**RE: DURHAM/YORK RESIDUAL WASTE ENVIRONMENT ASSESSMENT
STUDY – SITE SELECTION PROCESS
FILE NO. : E01.EN**

Report #: PSD-141-07

Subject: DURHAM/YORK RESIDUAL WASTE ENVIRONMENTAL ASSESSMENT STUDY -
SITE SELECTION PROCESS
MUNICIPAL COMMENTS ON STEP 7 – EVALUATION OF SHORT-LIST OF SITES
AND IDENTIFICATION OF PREFERRED SITE

Table 3.1 Comparative Evaluation Criteria for the Evaluation of Short-List Sites

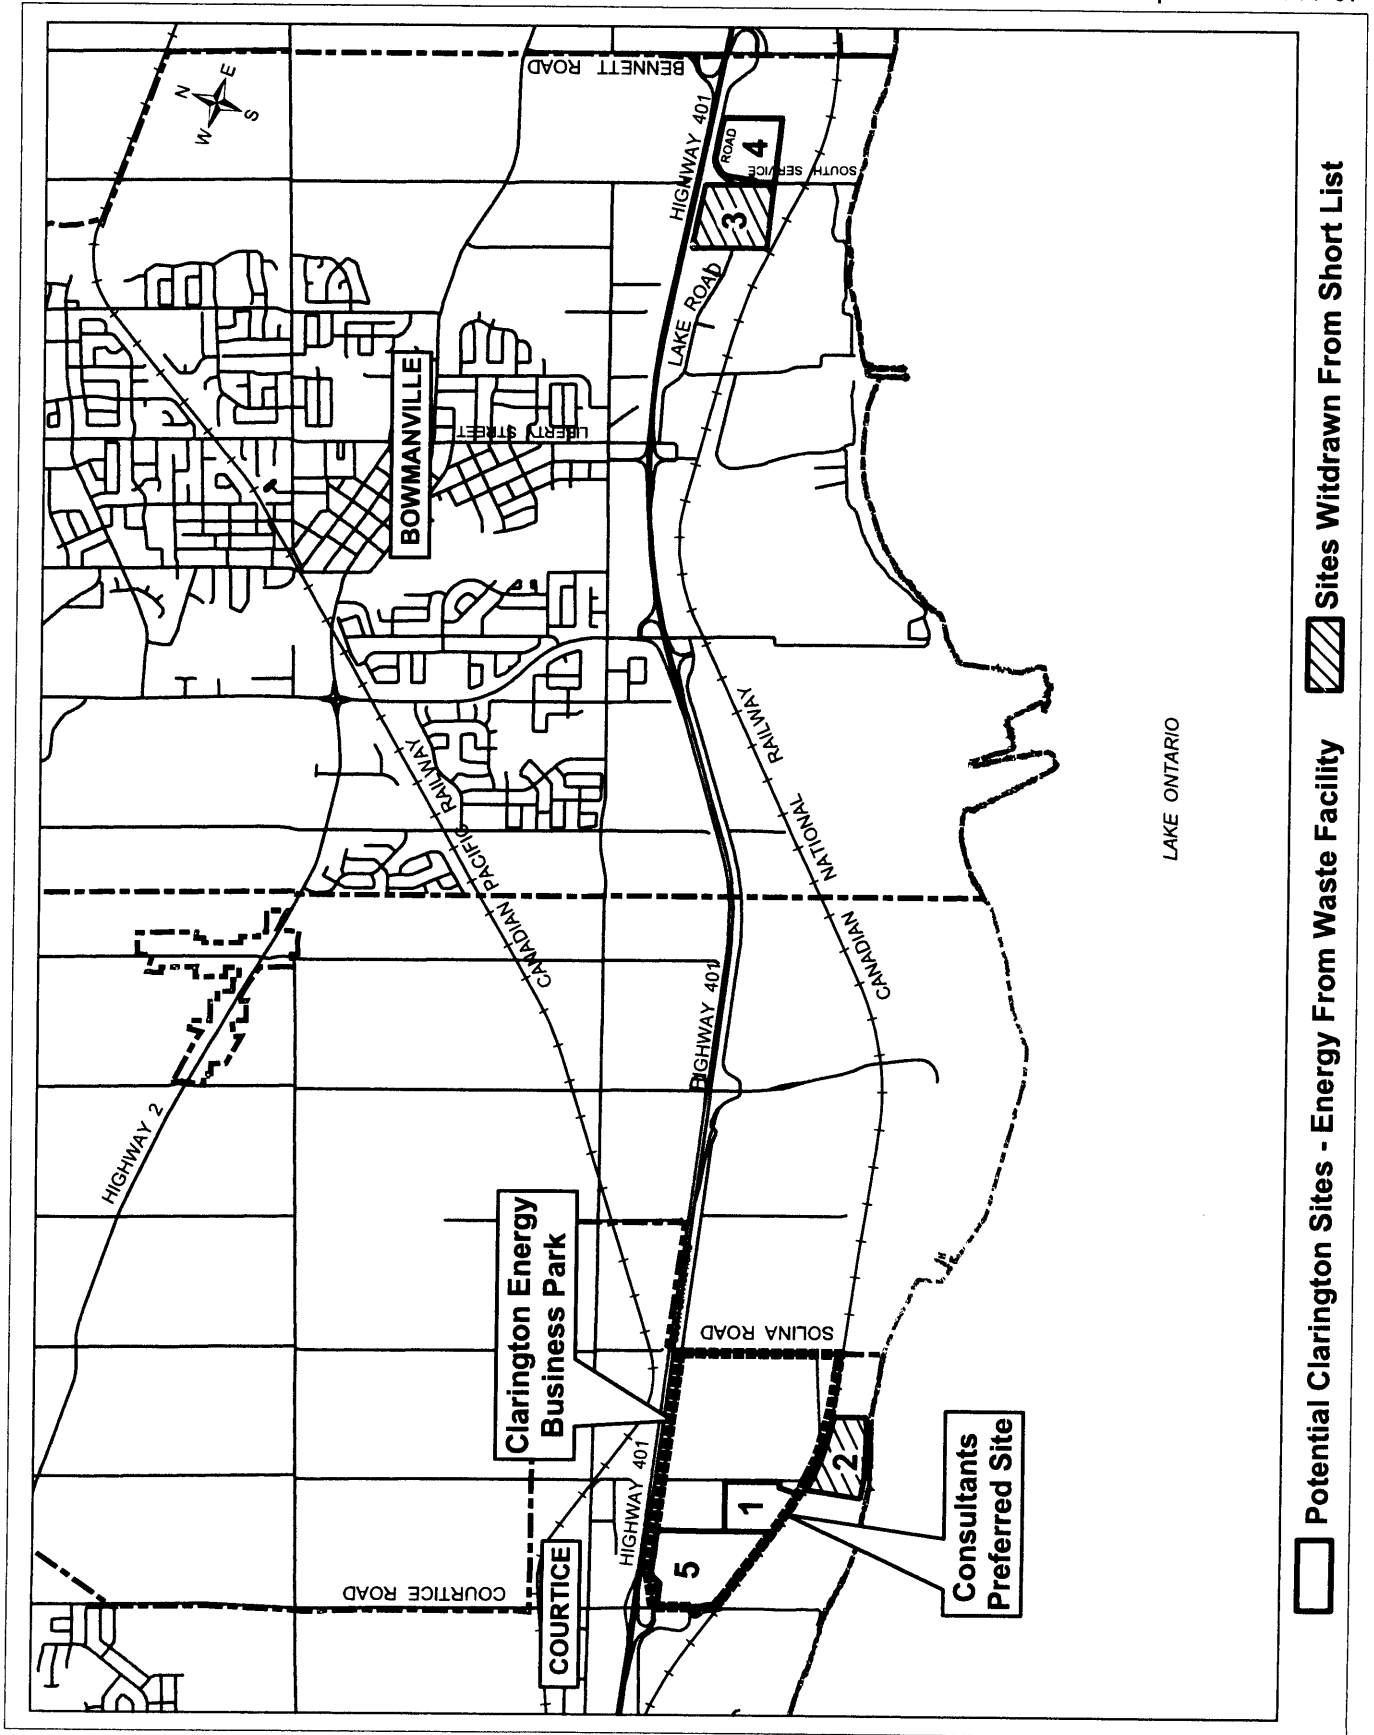
environment considerations in the overall evaluation. This effect is further compounded by the absence of a mechanism to assign relative priorities (ie. weight) to the different category groups as discussed above. It is unclear whether the public, when they were asked the questions about weighting of the criteria in March and June of 2005, had a clear understanding of how they would be employed and there has been no mechanism for confirming with the public that they concur with how the evaluation criteria has been applied.
